SERVICE BULLETIN

SB241

Replacing VFD

Affected machinery: Powered Skewed Conveyor

Figure 3: Front Cover and Wires

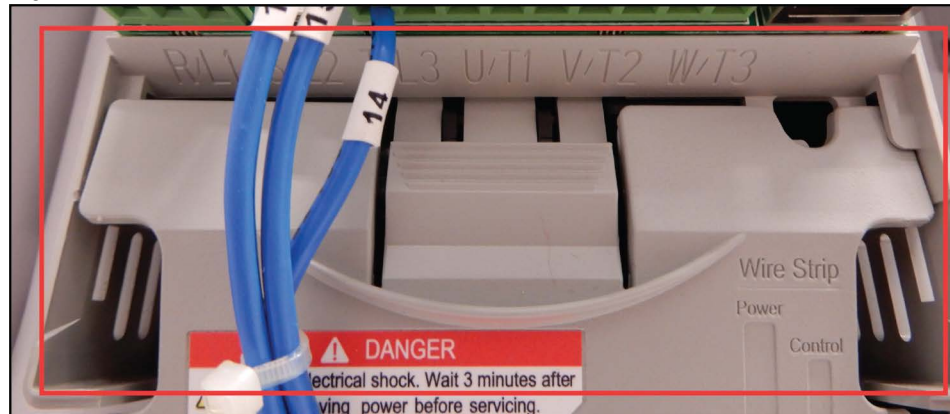
2. Remove the VFD's front cover and disconnect wires 10, 15, and 14.

Figure 5: ACS 380 Mounting Dimensions

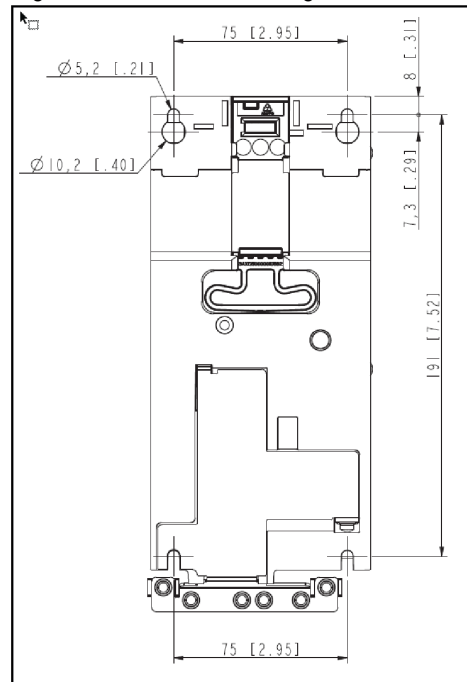
1. The ACS 380 should be installed in approximately the same location in the enclosure as the previous VFD. Before you start drilling, ensure that the ACS 380 will at least have 75mm of clearance at the top and bottom of the drive for adequate ventilation.
2. Using this supplies listed on page 2, drill and tap the mounting holes according to the measurements shown in Figure 5. All measurements are in millimeters [inches].

3. Once drilling is complete, use the included 10-32 screws, lock washers, and flat washers (in that order) to secure the VFD inside the enclosure.

Figure 6: Bottom Wires

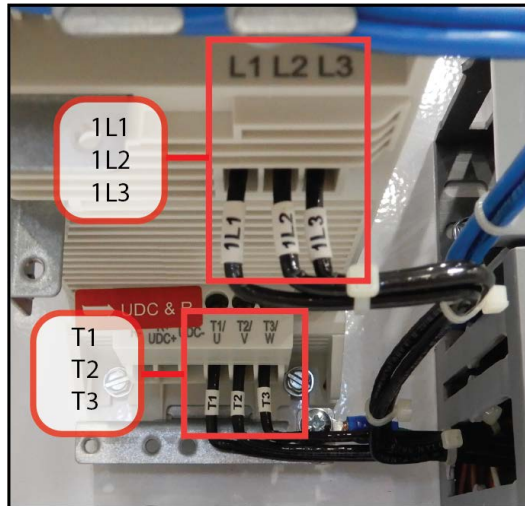
4. Connect the following wires to their matching terminals on the bottom of the VFD:
 - a) Wires 1L1, 1L2, 1L3 to matching terminals L1, L2, L3
 - b) Wires T1, T2, T3 to matching terminals T1/U, T2/V, T3/W

Figure 8: Front Wires

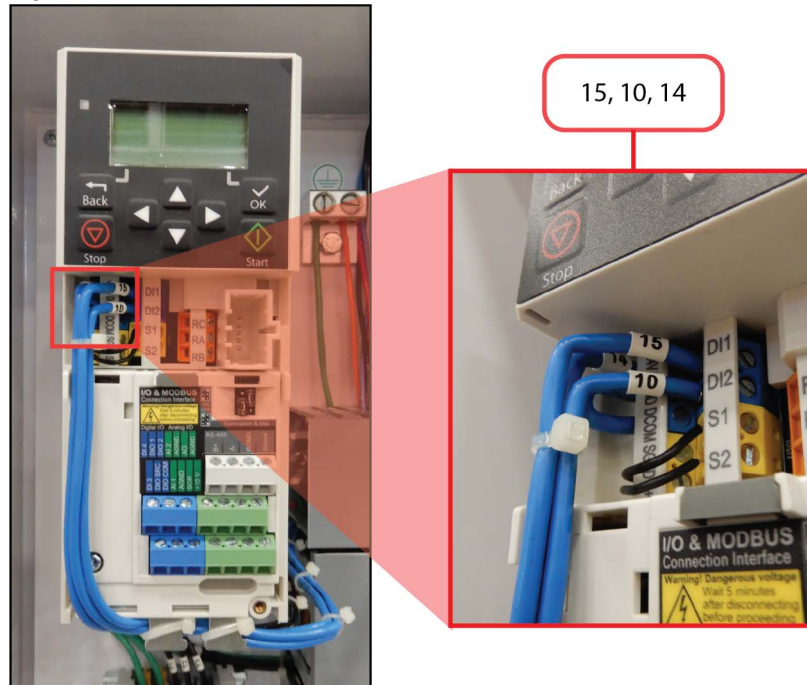
6. Connect the following wires to their matching terminals on the front of the VFD
 - a) Wire 15 to DI1.
 - b) Wire 10 to DI2.
 - c) Wire 14 to +24VDC.

Figure 9: Ground Wire Terminal

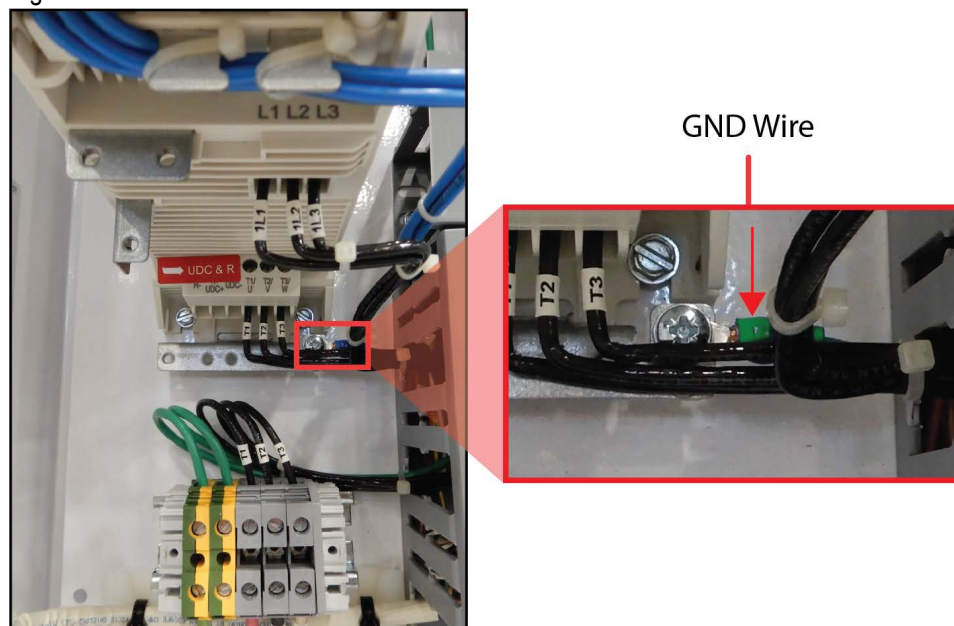
7. Connect the loose end of the GND (green) wire to the ground terminal.
